Modifications to front panel
for 4-channel temperature controller

Use Schroff 20817-443 plug-in unit panel, RS 258-2920

This panel is for a
"Digital Temperature Controller"
or "High precision temperature controller" if it fits!

DWG NO. Panel drawing

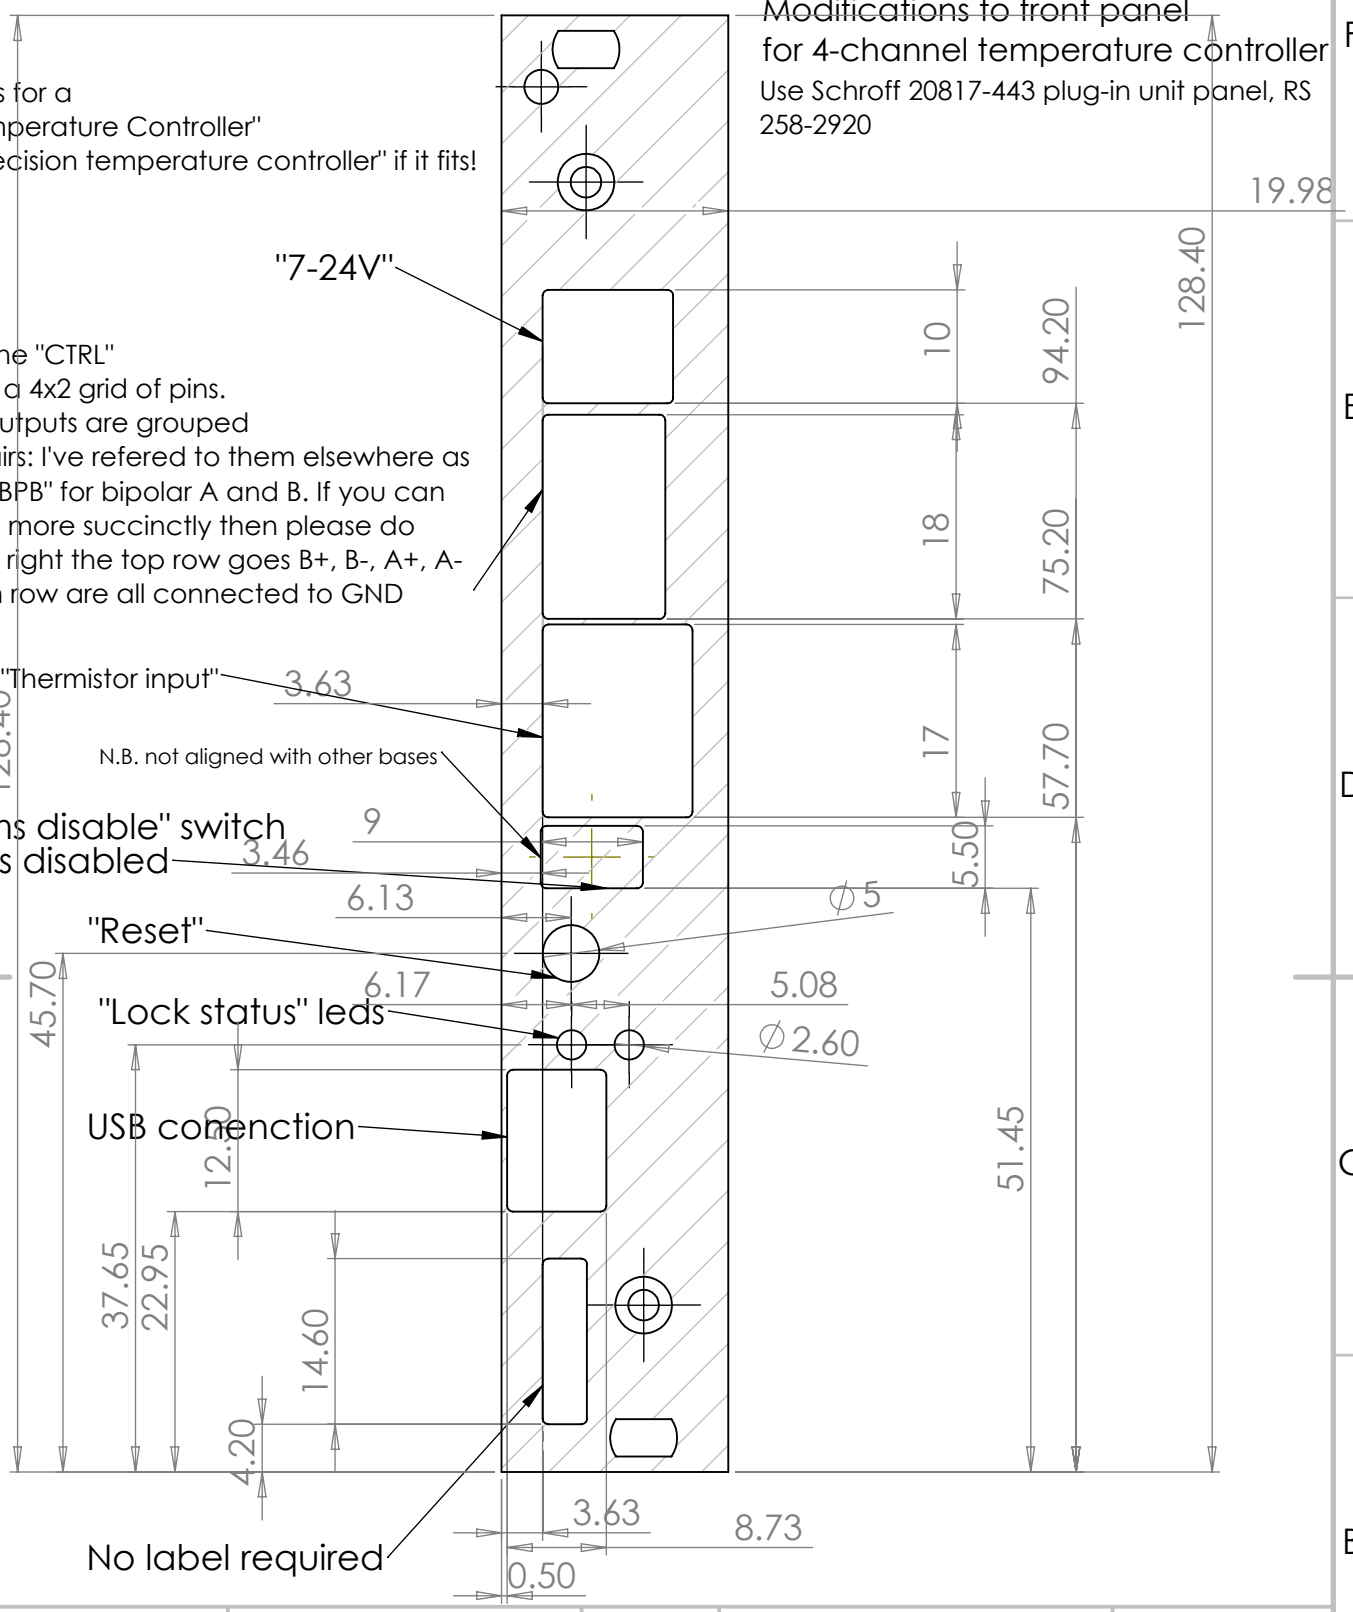
These are the "CTRL"
outputs: it's a 4x2 grid of pins.
The top 4 outputs are grouped
into two pairs: I've refered to them elsewhere as
"BPA" and "BPB" for bipolar A and B. If you can
convey this more succinctly then please do
From left to right the top row goes B+, B-, A+, A-
The bottom row are all connected to GND
